**SUBJECT: RAI Responses for Mixed Oxide Fresh Fuel Package License Amendment, Docket No. 71-9295 (TAC No. L24054)**

This transmittal contains the responses to the NRC Request for Additional Information (RAI) provided to Packaging Technology (currently AREVA Federal Services LLC) in the letter dated November 2, 2007. These RAIs are a result of a requested license amendment to the MOX Fresh Fuel Package (USA/9295/B(U)F-96).

**Attachment A  
RAI Responses**

Figure B6.4-1 – AFS-B with 175 MOX Rods

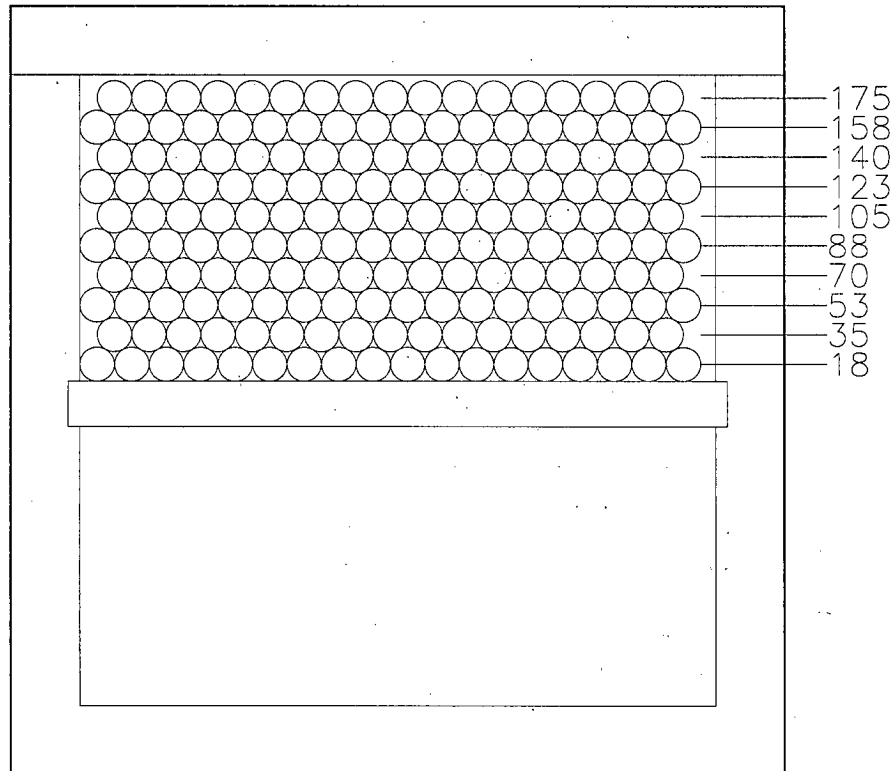
- B6-1** Justify the most reactive configuration if no structural credit is taken for the AA433 or fuel rods explicitly or explicitly.

*Response:* The AA433 in Appendix B has been replaced with a different box, named the AFS-B. The AFS-B may contain up to 175 standard MOX fuel rods. SAR drawings of the AFS-B are included in the application. It is demonstrated in Chapter B2, *Structural Evaluation*, that the AFS-B provides support to the MOX rods superior to fuel rods within a fuel assembly, which were shown to survive an HAC event without gross rod damage (such as broken fuel rods). The criticality analysis has not been revised, and is highly conservative because the AFS-B is not credited.

**Figure C6.4-11** – Configurations for Combined Rod Cases G2 through G4

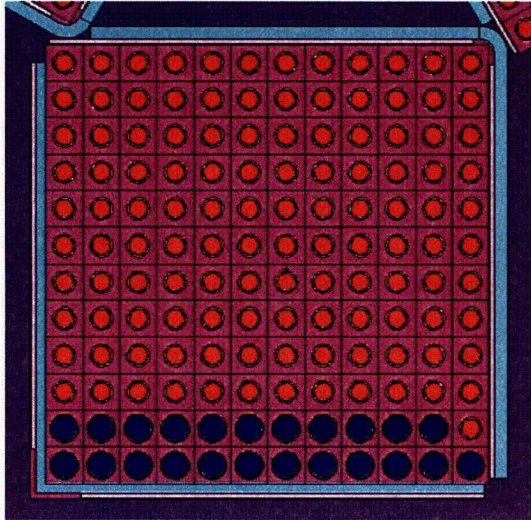
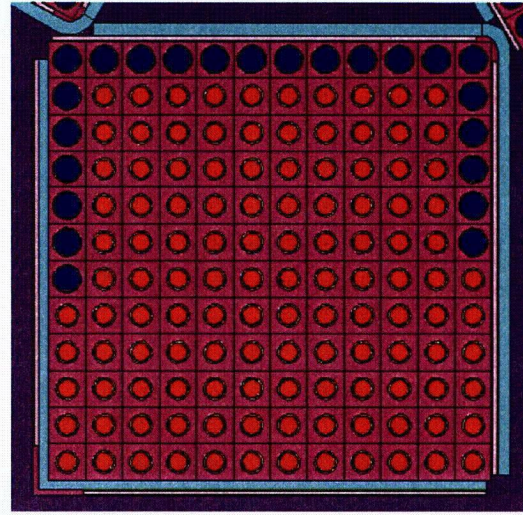
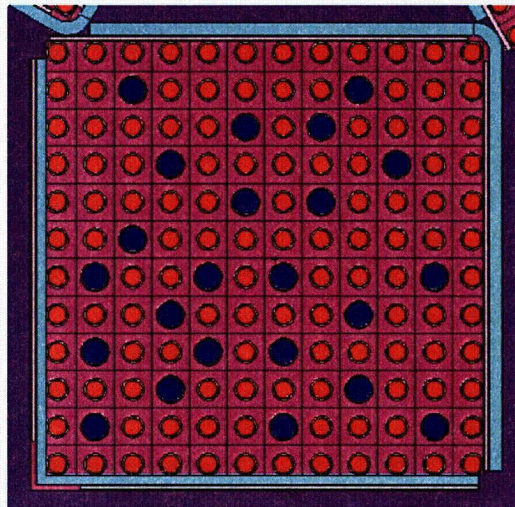
**C6-2** Provide engineering drawings to show structural arrangement of the contents including PNL pins, Exxon pins, and other structural components (e.g., basket, spacers, dunnage rods) within each AA433 rod container.

*Response:* Note that there is no requirement, from a criticality perspective, for the Exxon and PNL rods to be separated. Figures 6.4-11 and 6.4-12 show cases in which the Exxon and PNL rods are allowed to mix (see also Cases G2 through G8 in Table C6.4-7). When the Exxon and PNL rods are mixed, moderation is reduced and the reactivity decreases.
